**TO:** Planning Commission  
**FROM:** Ken Roberts, Planning Director  
**SUBJECT:** Easton Village 5<sup>th</sup> Addition Final Plat  
**REVIEWED BY:** Jack Griffin, City Engineer

The Commission is being asked to recommend approval or denial of the Final Plat request for the 5<sup>th</sup> Addition of Easton Village based on its consistency with the approved Preliminary Plat (revised on 6/21/2017).

**To:** Ken Roberts, City of Lake Elmo Planning Director  
**From:** Lucius Jonett, Wenck Landscape Architect  
**Date:** March 29, 2019  
**Subject:** City of Lake Elmo Landscape Plan Review  
Easton Village 5<sup>th</sup> Addition, Review #1

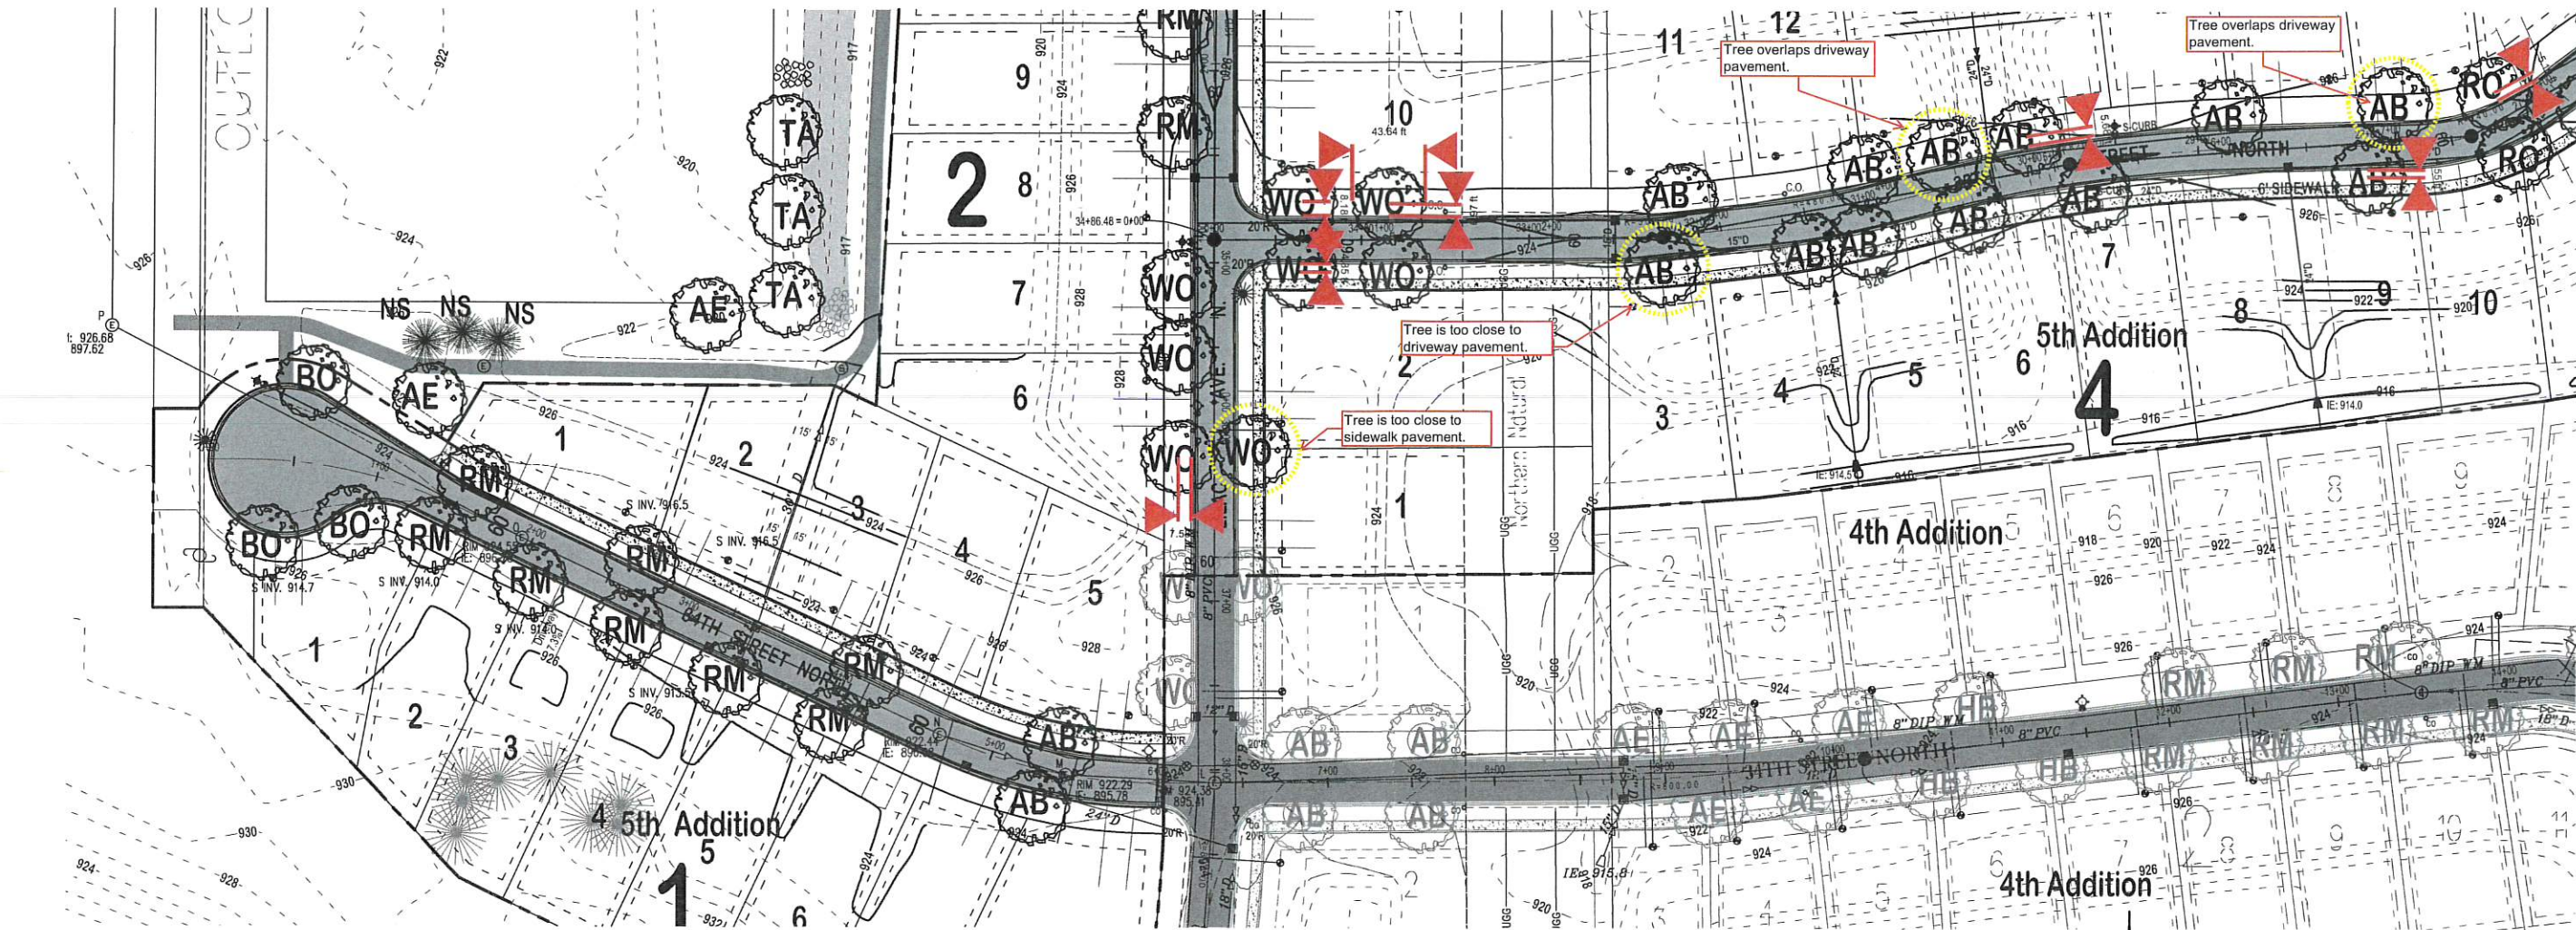
3. Several trees are shown over driveway pavement and need to be relocated. See attached figure highlighting the conflicts.
4. A few trees are placed within 10' of storm sewer utilities and need to be relocated to provide 10' from tree trunk to utility pipes.

5. Water and sanitary sewer utilities to the homes are not shown on the landscape plans and need to be included to show any tree placement conflicts.
6. Tree layout does not consistently match the typical ROW layout with boulevard trees 5' from back of curb when sidewalk is present and 8' from back of curb when no sidewalk is present.

7. City standard details are not used for planting details.

It is recommended that the conditions of approval include submitting a revised landscape plan showing the water and sanitary sewer utilities, including City standard details, and adjusting the tree layouts to resolve the conflicts noted in the findings above.

LANDSCAPE PLAN

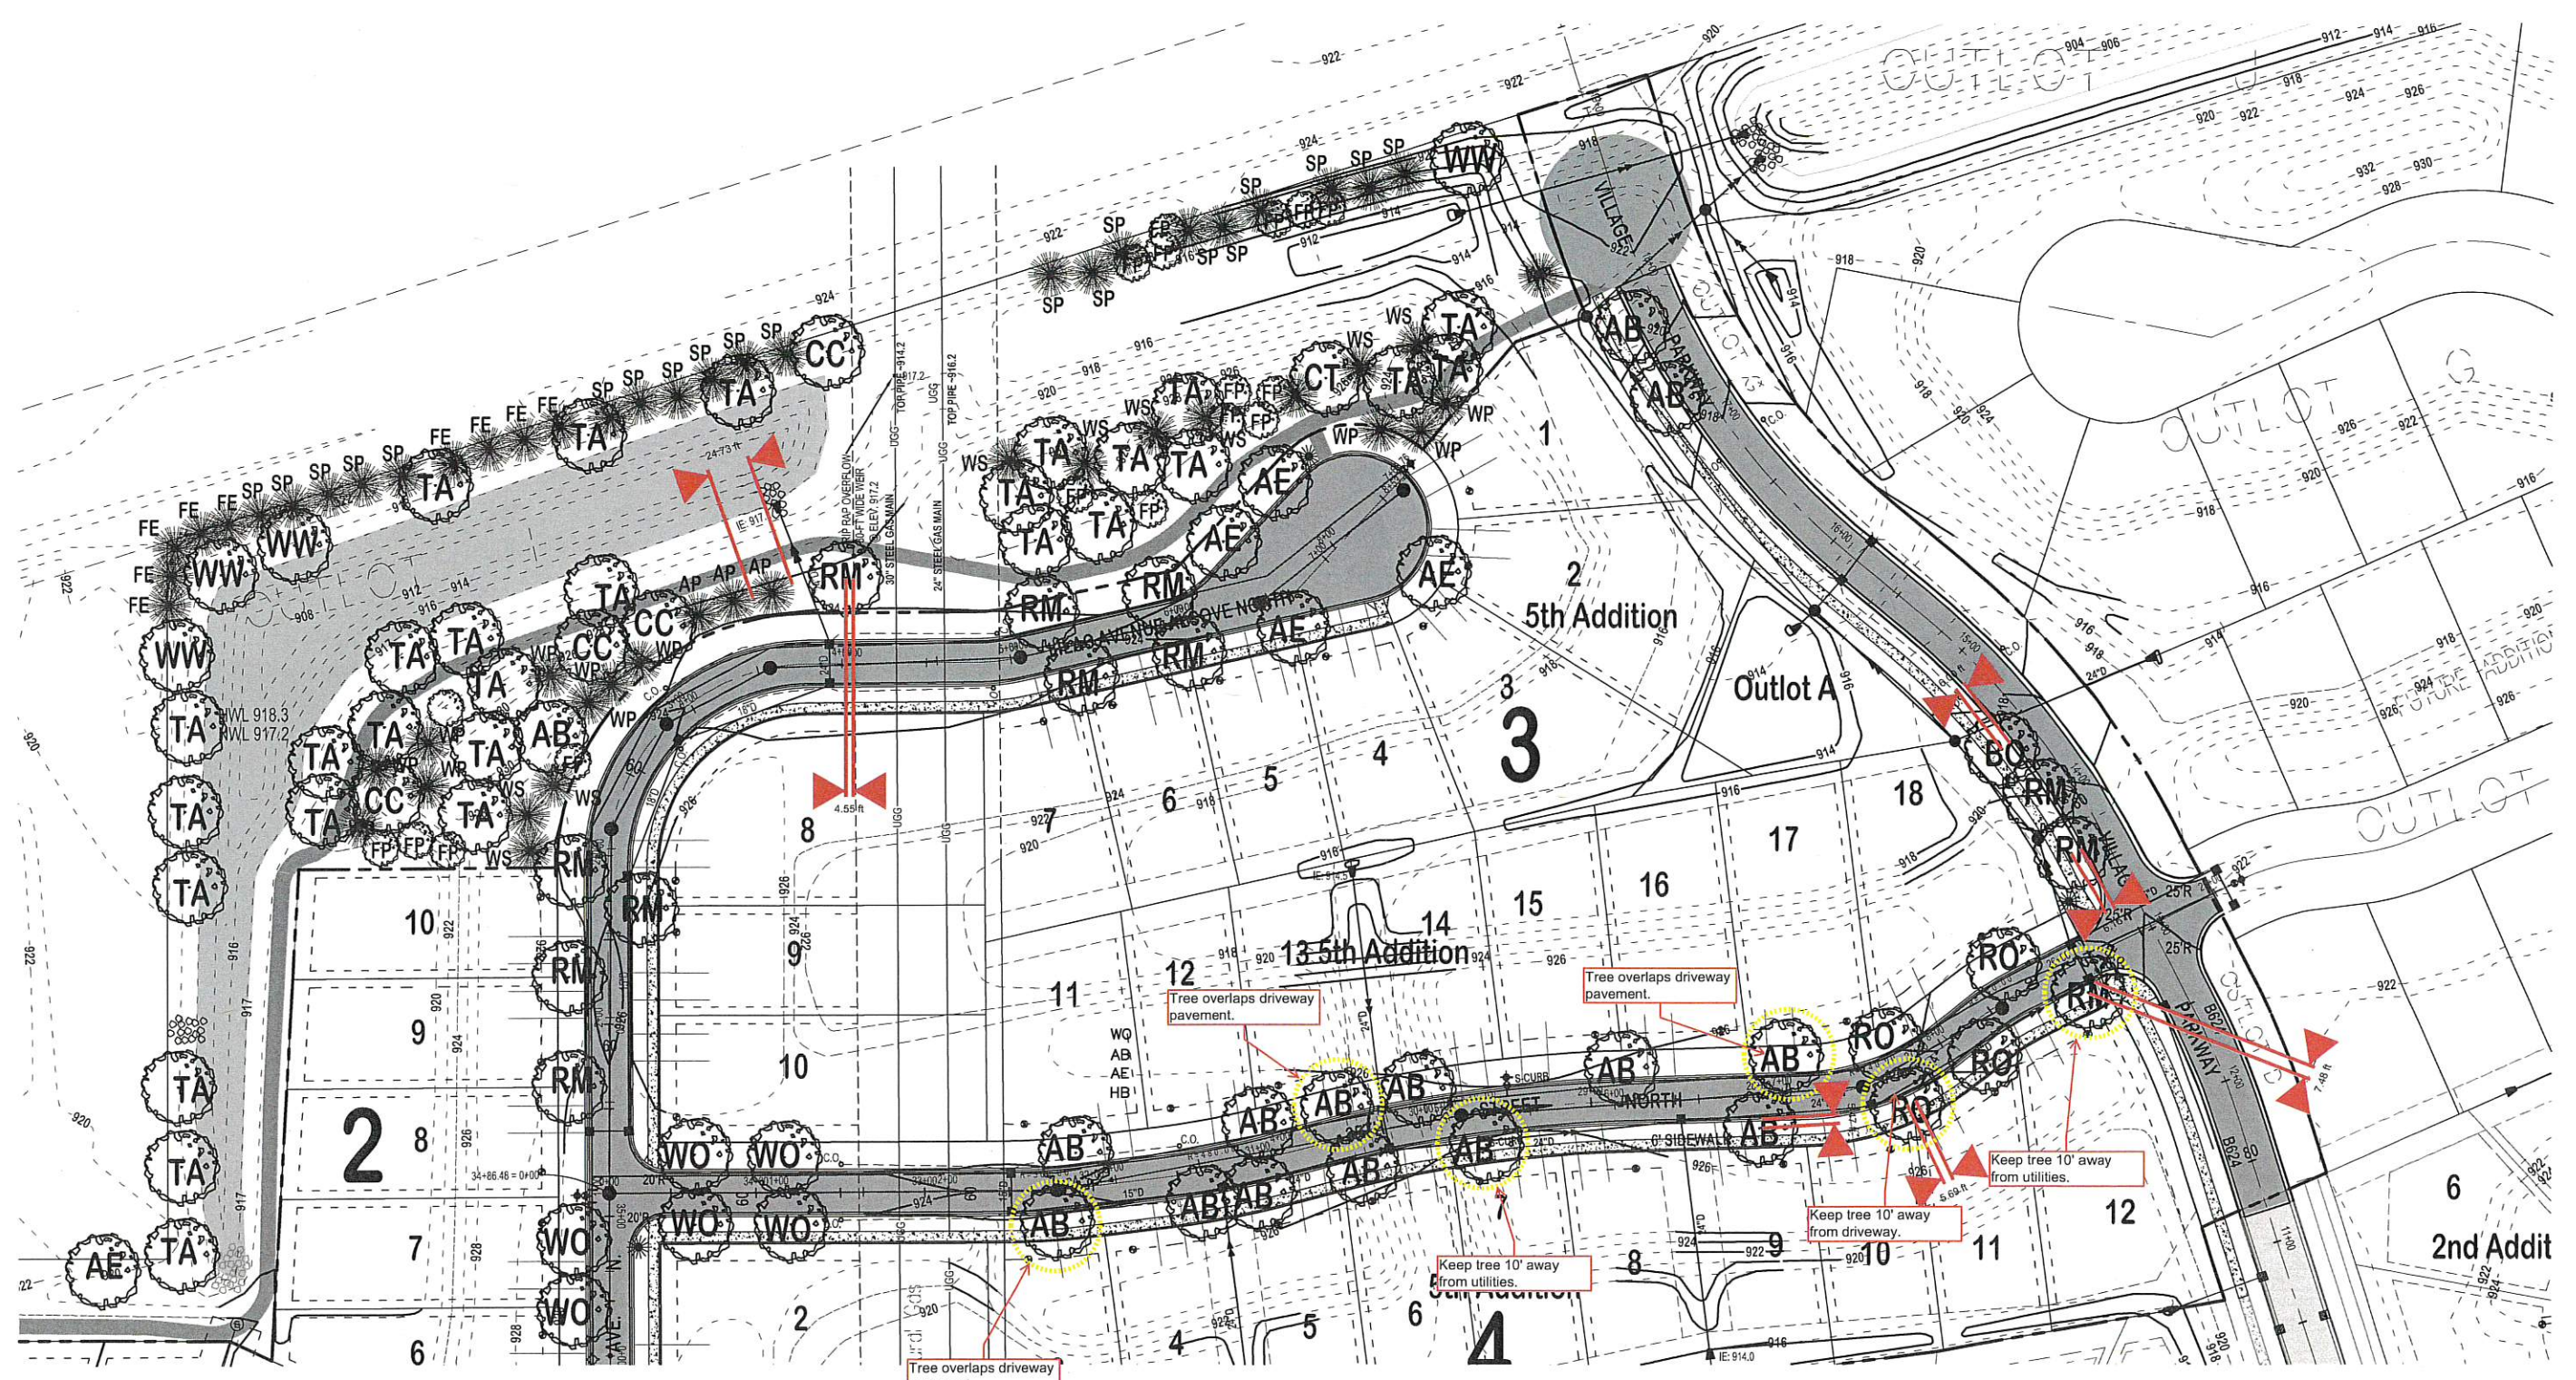
- A. A landscape plan has been submitted that **does not** include all requirements.
1. The landscape plan **does not** include required City standard notes and details.
  2. All utilities and pavements **are not** shown on the landscape plan to review for tree placement conflicts.
- B. The landscape plan **does not** consistently meet the landscape layout requirements:
1. Per typical Right of Way layout, place boulevard trees 5' from back of curb when sidewalk or trail is present, 8' from back of curb when no sidewalk or trail is present.
- C. Interior Parking Lot Landscaping – The development does not include interior parking lots.
- D. Perimeter Parking Lot Landscaping – The development does not include perimeter parking lots.
- E. Screening – The landscape plan does provide noise separation and screening from the railroad.
